Consumers
POWER
Company

MIDLAND PROJECT -
ALAB-106 MONTHLY REPORT FOR JULY 1980
DOCKET NOS 50-329 AND 50-330
FILE: 0.4.6 UFI: 70*01 SERIAL: 8816

LOG OF NONCONFORMANCE REPORTS

JOB NUMBER CL 238	UNIT NUMBER UNIT # 1	DATE 7-28-80	REPORT OF NONCONFORMITY # 1741
-----------------------------	--------------------------------	------------------------	--

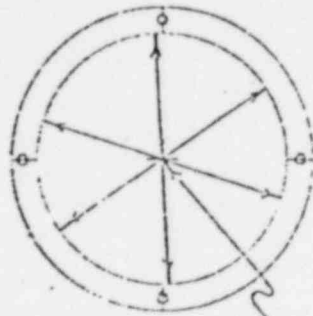
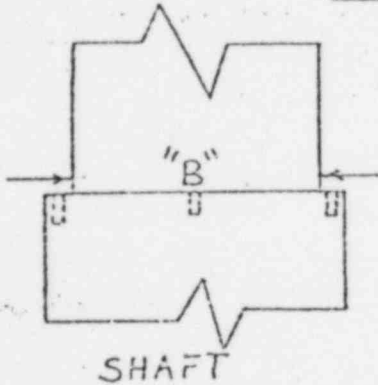
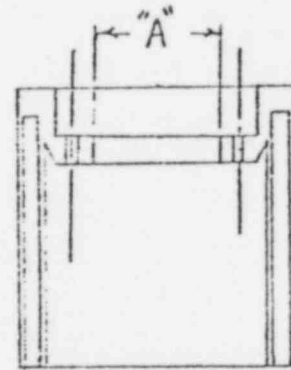
10. SPECIFICATION NUMBER N/A	11. DRAWING NUMBER 238856E, Rev. 2	12. PRIOR REPORT OF NONCONFORMITY N/A		
13. DESCRIPTION OF NONCONFORMITY After machining the flats for SSHT shims, the dimension from centerline of layout to far side of flat is 4 5/8". The Dwg. 238856E, Rev. 2 calls for a minimum dimension of 4 1/4".

ADD TO NCR #1688

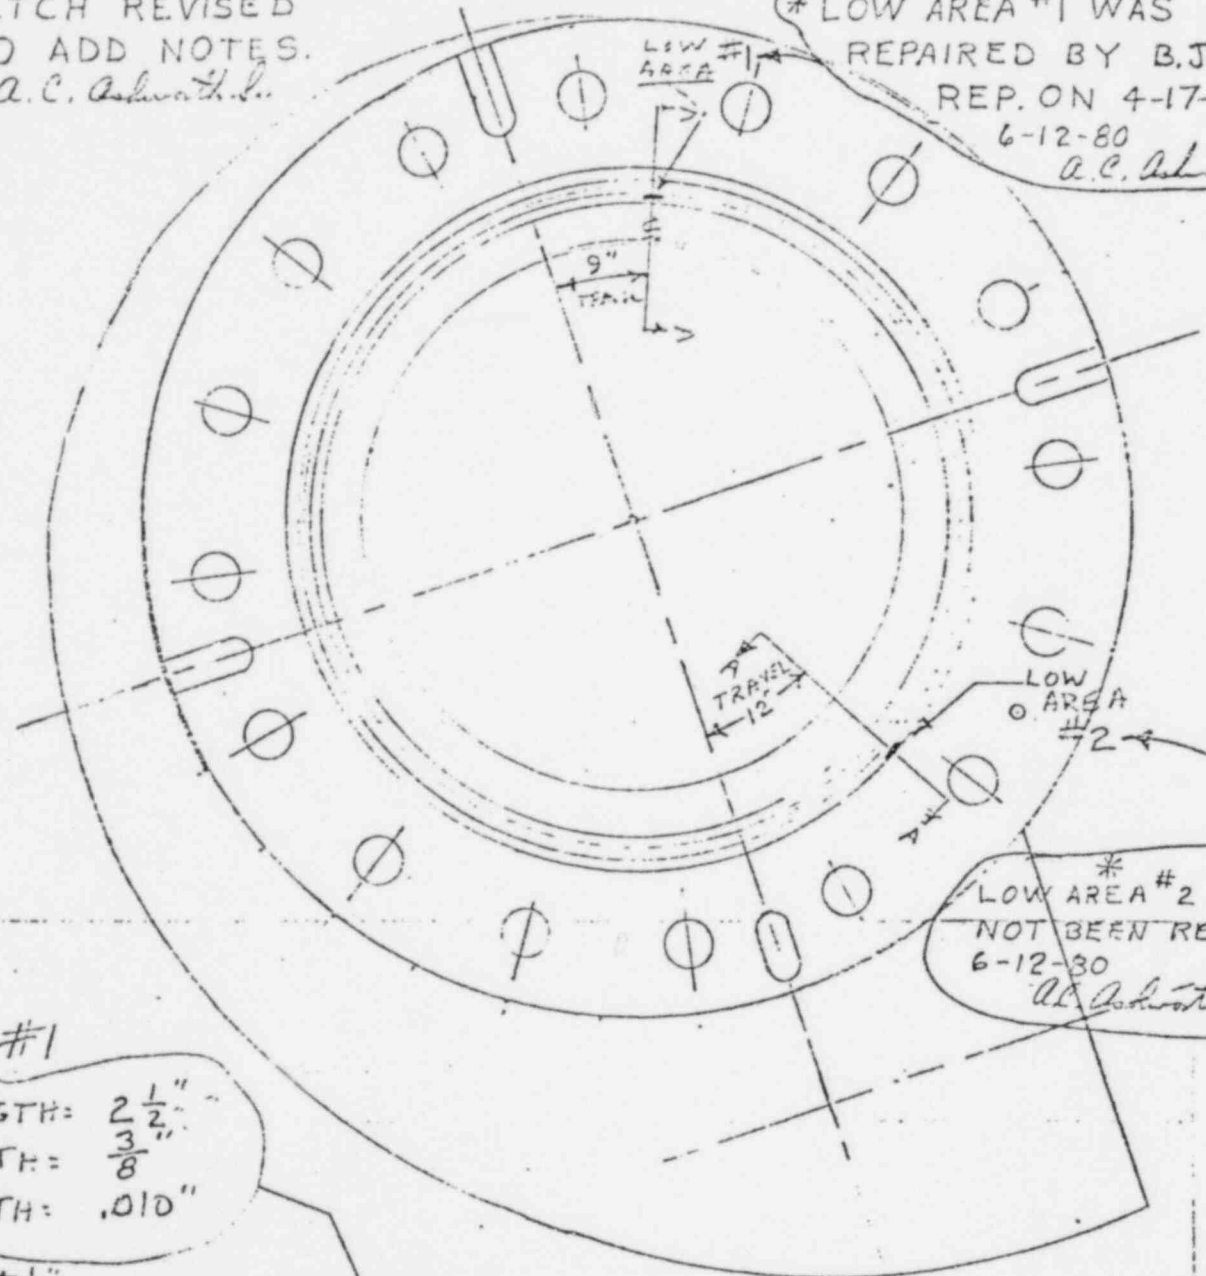
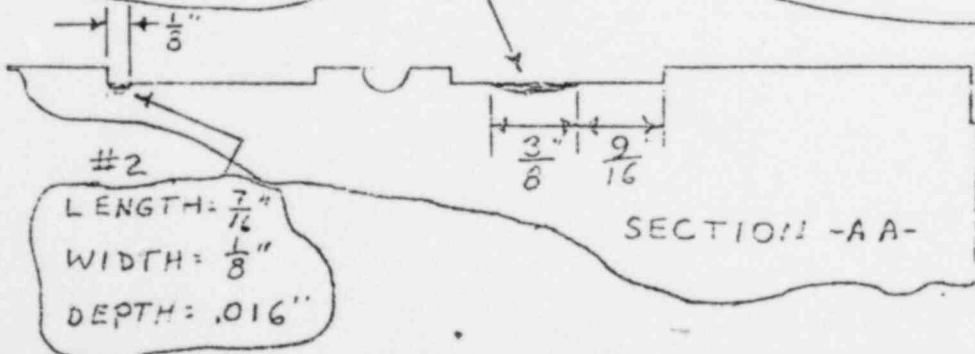
10. SPECIFICATION NUMBER FS III.3	11. DRAWING NUMBER 1F7623 Rev. K	12. PRIOR REPORT OF NONCONFORMITY: N/A		
13. DESCRIPTION OF NONCONFORMITY Several high and low areas are present in the gasket grooves of the pump casing. See attached sketch for details. 4-1-80 { See Page 3 of 3 for additional low areas discovered during repairs of low part { areas on Page 2.

* LOW AREA #1 WAS
REPAIRED BY B.J.
REP. ON 4-17-80.
6-12-80
A.C. Ashworth

* LOW AREA #2 HAS
NOT BEEN REPAIRED
6-12-80
A.C. Ashworth

Fig 1. Upper Cable Spreading Room.
 Note: Identification is side by side as shown at beginning of each tray section. This tray is near a wall and the opposite side is inaccessible.

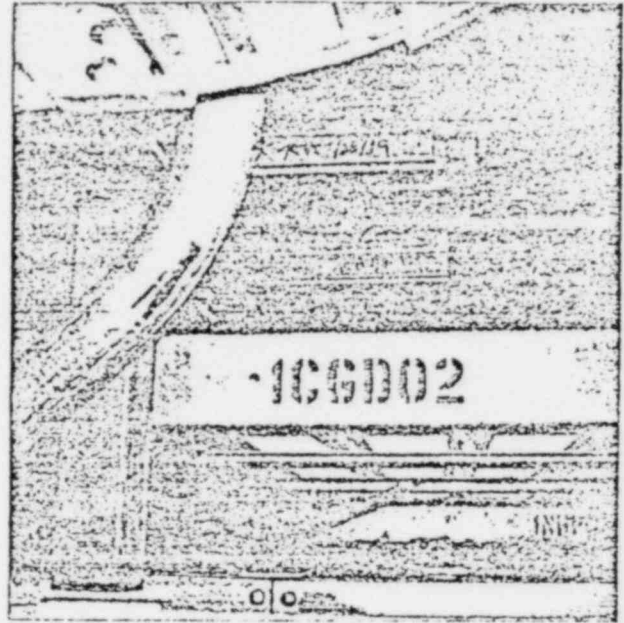
12. "AS IS" NONCONFORMING CONDITION VERSUS "AS REQUIRED" CONDITION WITH REFS: Drawing E-42, Sheet 8 paragraph 6 (A) & (B) describes methods of identifying cable trays which have been divided into two parts. Contrary to the above, divided cable trays in the upper and lower cable spreading rooms are not being identified with any consistency. See Page 3.						3. DATE OF REV: NA

Fig 2 Lower Cable Spreading Room.
 Note: This tray is identified on one side as 1CGD02, on the opposite side as 1CFA01. This tray section is open to view from both sides.

Fig 3 Upper Cable Spreading Room.
 Note: Tray is identified on each end of tray section. When viewed from the opposite side, identification is the reverse of that shown above, ie, 1DTB01 becomes 1DFA05.

4. FILE NO: 16.3.1, 16.3.4	
13. QA RECOMMENDATION FOR PART CA: 1. Clarify paragraphs 6 (A) & (B) of Drawing E-42 so that identification of divided cable tray is consistent. 2. Re-identify those cable trays not in accordance with paragraphs 6 (A) & (B) of Drawing E-42. DESIGN/PROJECT ENG. DISPOSITION REQUIRED <input checked="" type="checkbox"/> NOT REQUIRED <input type="checkbox"/>						5. DISTRIBUTION ACTION COPY: LADreisbach	
						INFO COPY: WRBird DBMiller RBCherba EDNewman JWCook RLRixford TCCooke(2) JARutgers JLCorley RASimanek LEDavis DATaggart PKHansen SHHowell GSKeeley BWMarguglio JMilandin
